Attachment 1 – Planning Report - Proposed Amendment to Homebush Bay West DCP for Block H, 16 Burroway Road and Part 5 Footbridge Boulevard, Wentworth Point

Block H DCP Amendment and Planning Agreement Submission RZ/27/2016

**REF: (RZ/27/2016), AMENDMENT NO. 2 TO HOMEBUSH BAY WEST DEVELOPMENT
CONTROL PLAN AND DRAFT PLANNING AGREEMENT FOR
BLOCK H, WENTWORTH POINT**

**PUBLIC EXHIBITION OF DRAFT AMENDMENT NO. 2 TO HOMEBUSH BAY WEST
DEVELOPMENT CONTROL PLAN AND DRAFT PLANNING AGREEMENT FOR
BLOCK H, WENTWORTH POINT**

Figure 6: Proposed Scenario 1 (image provided by the Applicant)

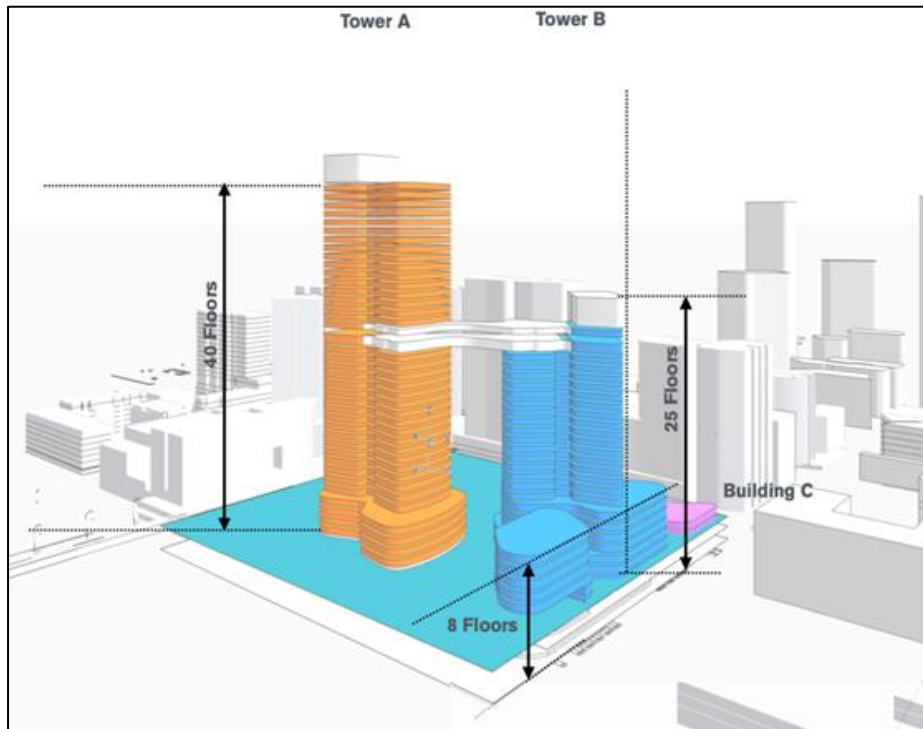
Council officers raise significant concerns regarding the proposed maximum building height. Following detailed analysis, Council officers consider the proposed tower heights to be out of context with the surrounding area. This has been previously raised by Council officers in the 11 May 2020 Council report.

Figure 1: Proposed building envelopes and heights including non-residential upper storeys for articulation purposes.

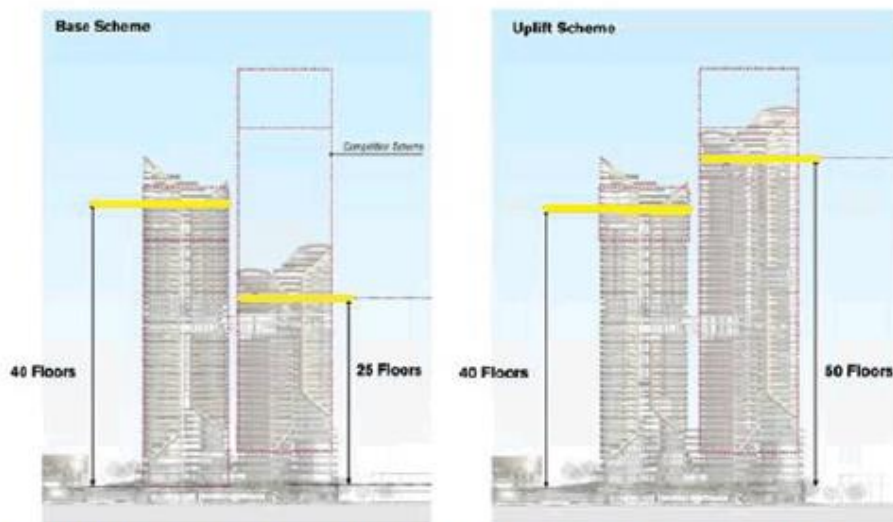
SINSW notes that the proposal aims to increase the maximum permissible height limit for Block H, from 25m (under Section 5.3.2 of the current DCP), to 50 storeys under Scenario 2 (57 storeys including articulation zone), or 40 storeys under Scenario 1 (47 storeys including articulation zone). The reports accompanying the proposal note that this is sought to enable the council-endorsed residential GFA to be delivered on the site (approximately 85,000m²).

These heights significantly exceed what is currently allowable in terms of bulk and scale for the locality and may consequentially enable development which will overshadow the aforementioned school site. SINSW therefore requests additional information be provided regarding the extent of the proposed massing shadow on Wentworth Point PS. If solar access is found to be impacted on the school site, it is requested that the proposed heights for Block H be reduced to both mitigate the impacts of scale on the school and better align the development with the future character of Wentworth Point, this being a high density residential suburb.

Figure 2: Site Layout

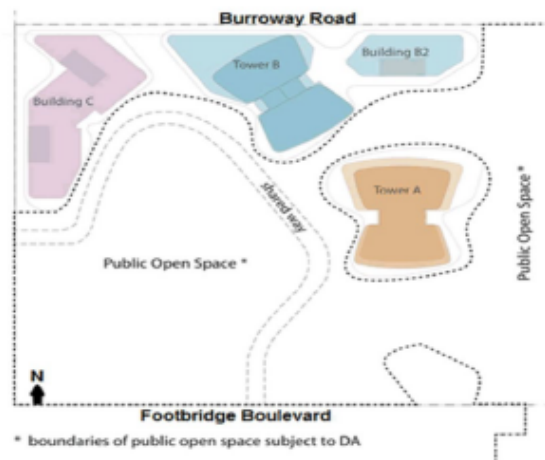
SINSW notes that the shared way outlined in Figure 6 of the exhibition material (refer below) does not appear to provide a connection between Footbridge Boulevard on Bennelong Bridge and the Waterfront Promenade.

SINSW is highly committed to encouraging safe travel routes to and from schools. An additional connection from the footbridge will prevent those students who walk to school (or take active transport) from having to cross this road. Further, as it appears that this space will be dedicated to the 'Community Organisation' under the proposed 'Draft Block H Voluntary Planning Agreement' (thereby becoming privately owned land) the introduction of a new connection/shared way is better suited to an amendment of the open space requirements under the HBWDCP (Volume 1).
